## **A Review of:**

### **Final Report on the Effects of Developing Angel Oak Village on the Angel Oak**

**James D. Gregory, CPSS, PWS, Ph.D.**

**March 21, 2009**

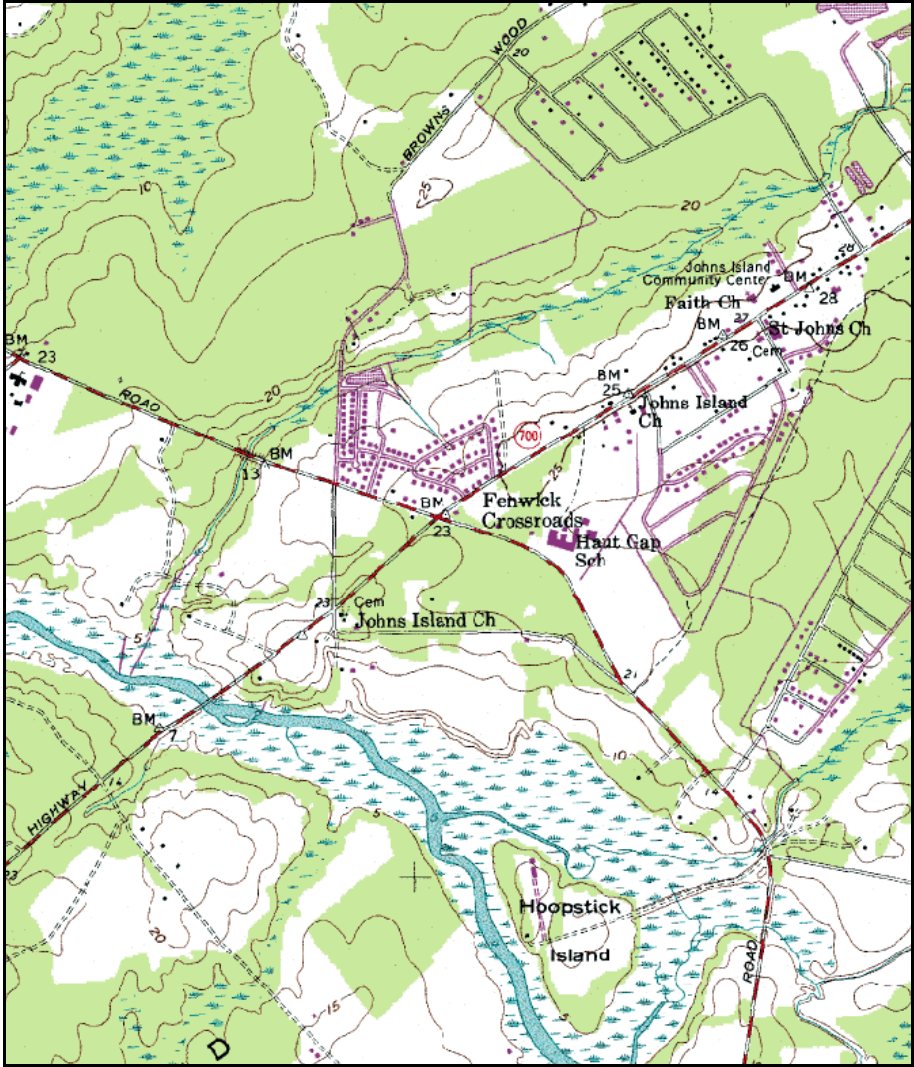
There are no streams on the Angel Oak Village site nor in the immediate vicinity of the site and surface runoff is an insignificant flux component in the water balance of the Village site. The dark blue lines drawn by Everett on the U.S. Geological Survey 1:24,000 scale topographic map of her Figure 3 that she calls “Major Drainages” are very misleading. Those features are not “drainages” as that term is used by hydrologists and they are most certainly not streams as the dark blue color implies. Most of those features are shallow swales that carry stormflow only during very infrequent, high volume storm events. There is a network of stormwater ditches in the developed area to the north and east of Fenwick Crossroads but the purpose of those ditches is to transport stormwater draining from impervious surfaces. Those stormwater ditches produce a pattern of surface runoff that is dramatically different than the supposed pattern of “surface drainage” described by Everett.

The hydrologic characteristics of the site that are described above are typical of low elevation, gently rolling landscapes along the southeastern coastal zone that are derived from ancient beach zones. My studies of the hydrology of the Buxton Woods area of Hatteras Island on the Outer Banks of North Carolina documented a hydrologic regime that is quite similar to that of the Angel Oak Village site (Gregory 1995, Gregory and Morgan 1996). The Village site is near the crest of a hydrologic peninsula bounded by streams on three sides (Figure 1). The highest elevations along the spine of the peninsula are along Maybank Highway. The subsurface water divide likely coincides closely with the zone of highest surface elevations.
